QUALITY ASSURANCE -- NON-CONFORMANCE REPORT

Report No: NCR-000557

Reference Description: Base Metal Repairs without Engineer's Approval, L6W

Job Name: SAS Superstructure

焊缝返修位置示意图:

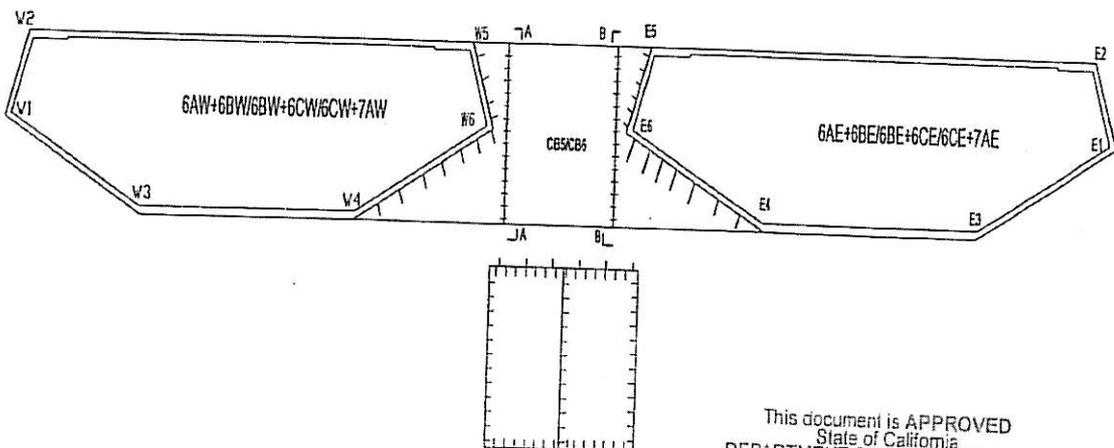
经检查发现西线 6AW+6BW/6BW+6CW/6CW+7AW 和东线 6AE+6BE/6BE+6CE/6CE+7AE 吊装段联系梁侧斜底板及腹板以及 CB5 及 CB6 顶板、底板、腹板、隔板马板去除后母材需修补。具体位置见下图所示:

After inspection west linear 6AW+6BW/6BW+6CW/6CW+7AW and east line 6AE+6BE/6BE+6CE/6CE+7AE lifting side plate and edge plate face strut plate, CB5 and CB6 deck plate, side plate, edge plate, floor beam attachment temporary, the base metal needed to repair

工人操作失误, 导致母材损伤。

Worker operator error caused base metal gouged.

1. QC和CWI在整个修补过程中都应在场并指导以确保返修按照处理意见以及AWS D1.5要求进行;
 2. 按照焊接返修工艺规程 (WPS) 打磨缺陷区域至光滑;
 3. 准备一个正确的接头形式, 具体参见返修的WPS;
 4. 在NDT检测前口头通知QA。对返修区域作100%MT和100%VT检查;
 5. 如果仍发现有缺陷, 通过打磨的方法去除所有缺陷以确认缺陷完全被消除, 并重复第四步以确认缺陷完全被消除;

6. 将杂物以及MT检测遗留的残留物清理干净;
 7. 根据批准的焊接返修工艺规程 (WPS) 进行预热及焊接;
 8. 将焊接区域打磨至与母材平齐;
 9. 在NDT检测前口头通知QA。对返修区域作100%MT和100%VT检查。
1. QC and CWI should be present to witness the repair, direct and supervise all repair operations during this repair to ensure the repair is per the disposition requirements, and the AWS D1.5 code requirements.

2. Grind the repair area to a smooth finish according to the approved repair WPS.
 3. Prepare the joint according to the approved WPS.
 4. Notify QA verbally prior to NDT. Perform 100%MT and 100%VT of the repair area.

5. Remove all defects by grinding to ensure all defects are completely removed if defects still exist, and repeat "step 4" to assure complete removal of all defects if necessary.

6. Clean the repair area of all loose debris including MT powder.
 7. Preheat and weld according to the approved WPS.
 8. Grind the weld flush after welding.

9. Notify QA verbally prior NDT. Perform 100%MT and 100%VT of the repair area.
